DESCRIPTIVE REPORT

Type of Survey Hydrographic
Field No. RA-10-3-89
Registry No. H-10305

State Alaska
General Locality Alaska Peninsula
Sublocality Nakalilok Bay

Descriptive Report to Accompany Hydrographic Survey H-10305

1904 cov ft at MLLW

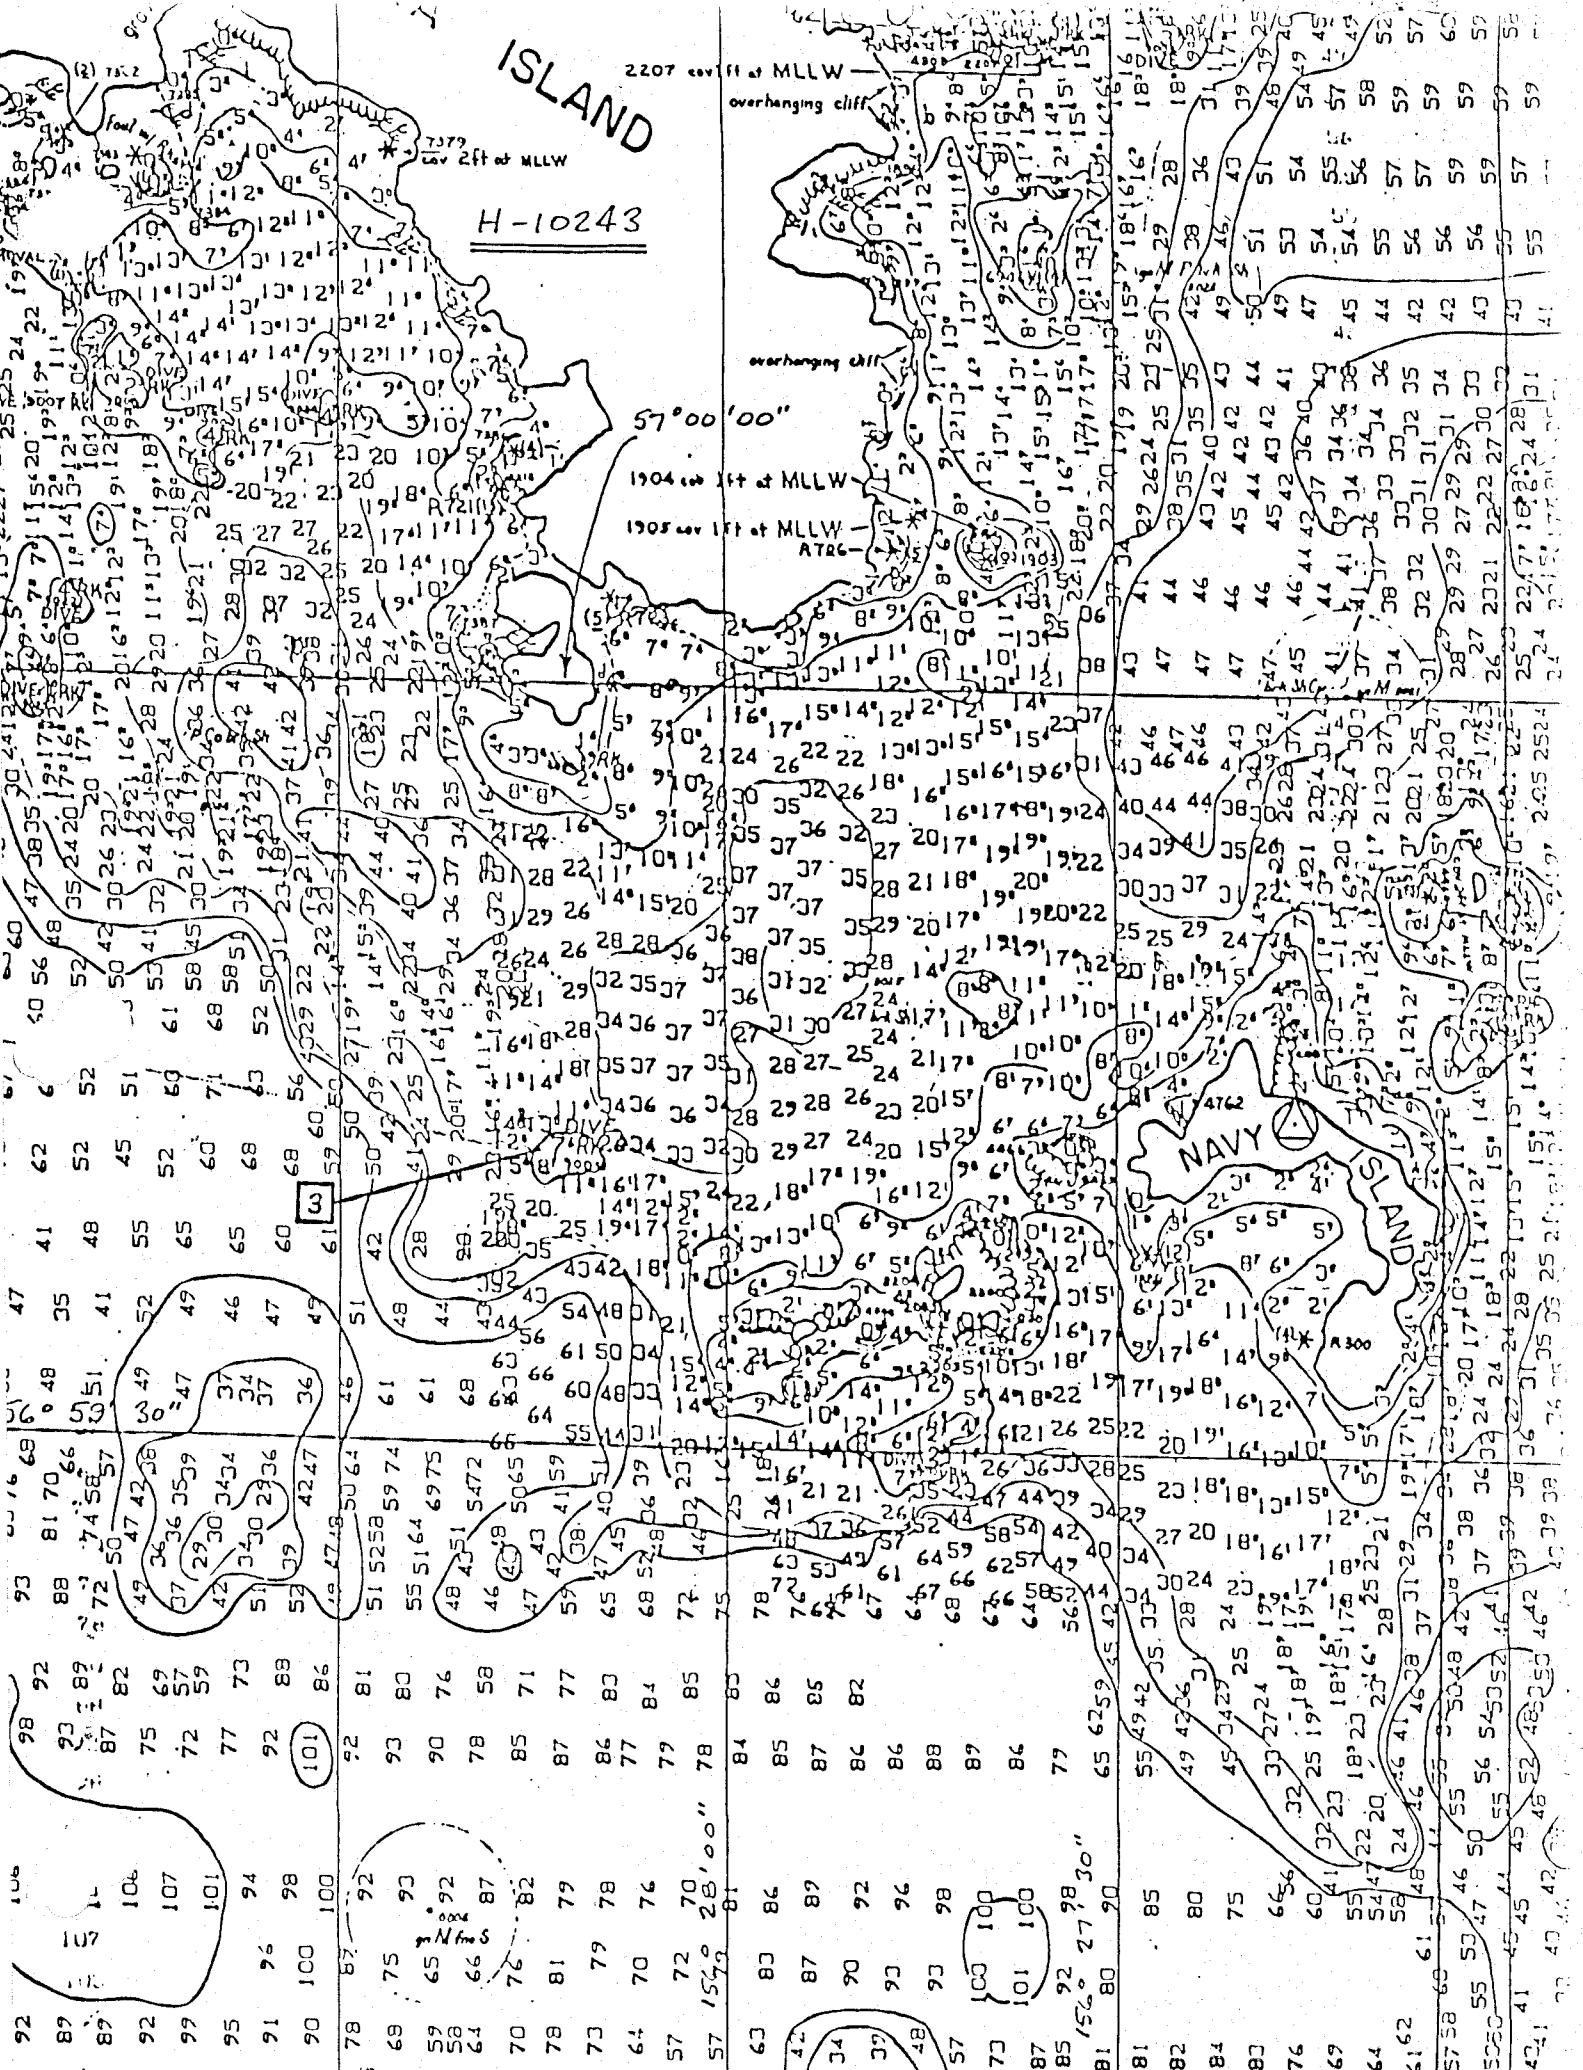
We recently received the new edition of Preliminary Chart 16568 which includes 1987 and previous survey data. A cursory comparison of the chart compilation with FAIRWEATHER field sheet H-10243 (1987) in the Cape Providence area raises several concerns. Either crucial survey data exists but was not shown on the final field sheet or excessive cartographic license was taken during chart compilation. The items below are numbered correspondingly on the attached copies of portions of Chart 16568 and survey H-10243.

1. Does a rock awash really exist at this location, as the chart indicates? Survey H-10243 shows only a least depth of 5.5 fathoms over a rock, as determined by divers. Last summer I selected a route into Chiginagak Bay which passed just south of this feature, between it and the 4-fathom shoal to the south, based on all information available on our copy of field sheet H-10243. Consequently, RAINIER has passed close aboard to this feature many times both last year and this, at various stages of tide. We've seen no evidence of a rock awash. The same is true of our launches and small boats working in the area. If this rock awash exists I will give this area a wider berth. If not, the chart should be revised to accurately portray the available depth.

2. The survey records need to be examined to determine if this feature really has a least depth of 4 1/4 fathoms, as charted. I suspect the true depth may be 14 fathoms. Close inspection of a mylar copy of the field sheet reveals that a "1" in front of the "4.2" may have been partially erased to make room for the hand-lettered "11.9." The sounding just to the west is 15.7 fathoms, the "1" just barely discernible on the mylar copy. Adding to my doubt is the absence of a dive investigation on this feature, even though a deeper sounding 0.4 n.m. west, 7.1 fathoms, was dove, and the fact that the feature was apparently not reported as a danger to navigation, as far as I can tell from the marginal notes. Also, the field sheet shows neither the 10- nor 5-fathom depth contours around this feature.

We have not been able to determine how the rocks awash, referred to in your memorandum of July 17, 1989, came to be charted on the 6th edition of chart 16568. The most likely explanation is a misinterpretation of the labels "Rk" on the survey.

ATTACHMENT A - Displacement of Stations

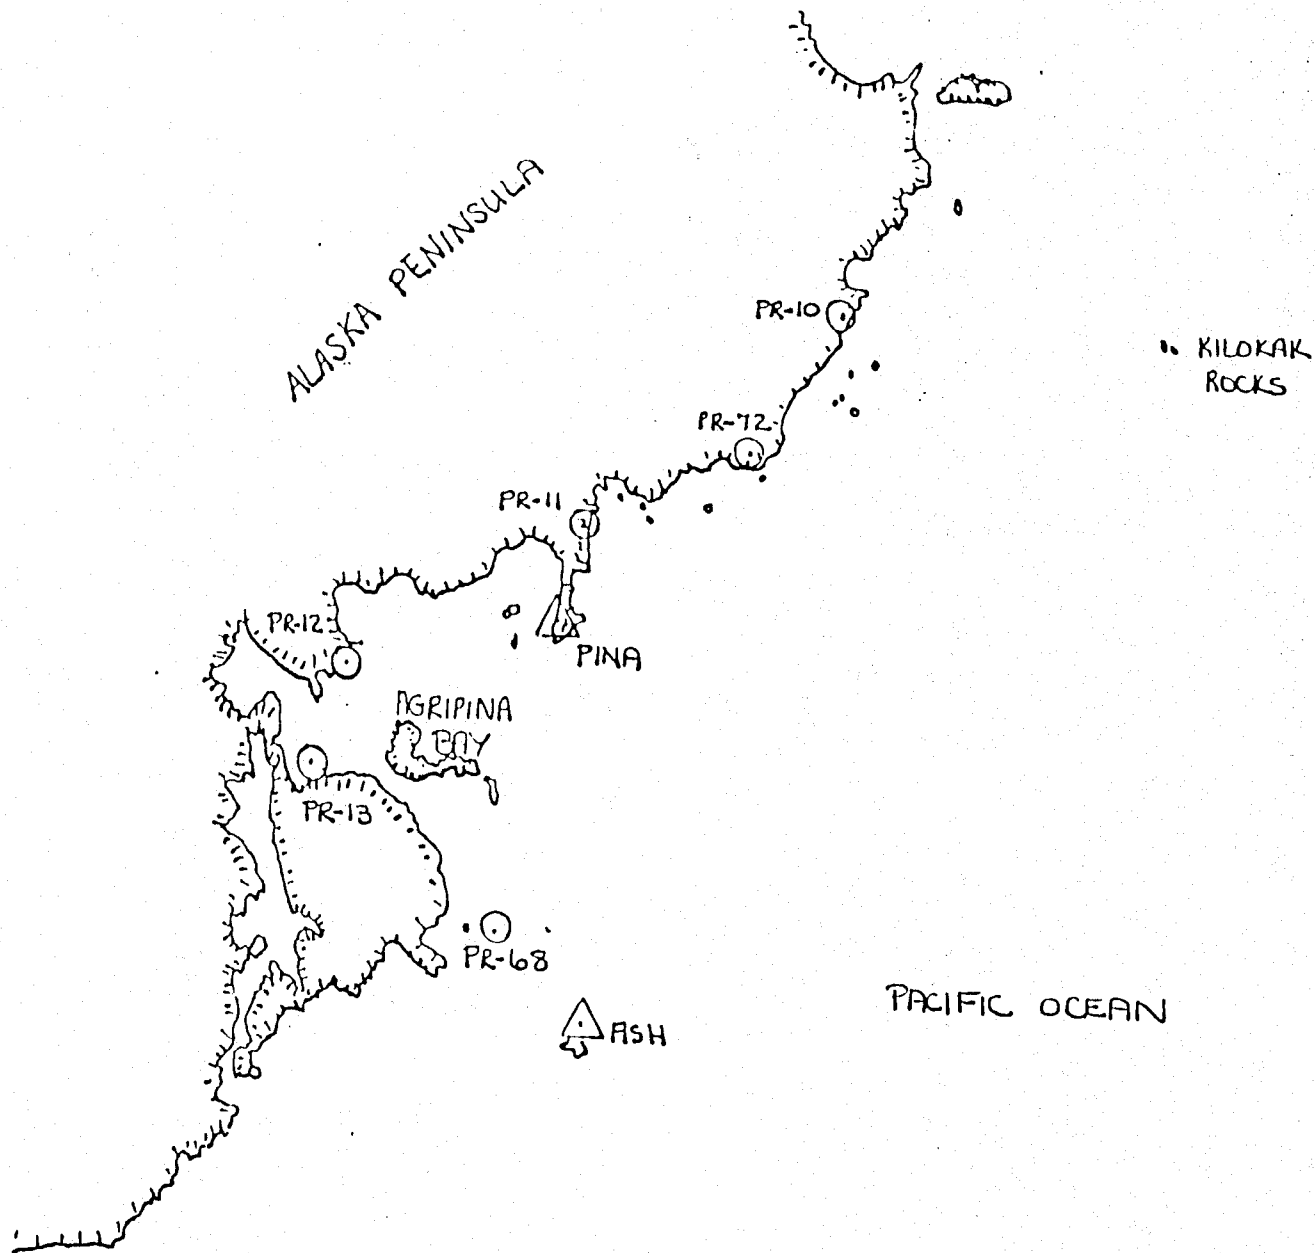
To verify the location of station PR-12, launch critical system checks were accomplished using theodolite intersection. Differences of 15 to 20 meters from the Mini-Ranger baseline correctors were found. To verify other photo stations, a First-Order geodetic station (ASH) was occupied with horizontal angles (four-plate settings) turned from a First-Order station (PINA) to PR-72, PR-10, and PR-11. Using the computed distances from ASH to the aerotriangulated stations, differences between the observed and computed angles leads to positional errors of 17 to 18 meters (see Attachment A).

It is recommended that Job CM-8200 be reviewed as an 18-meter error to the east is suspected in both the aerotriangulated positions and the shoreline. FAIRWEATHER will not attempt to use any photogrammetric station positions from this project until the problem is resolved. Geodetic control has been extended south to Cape Providence as of this time.
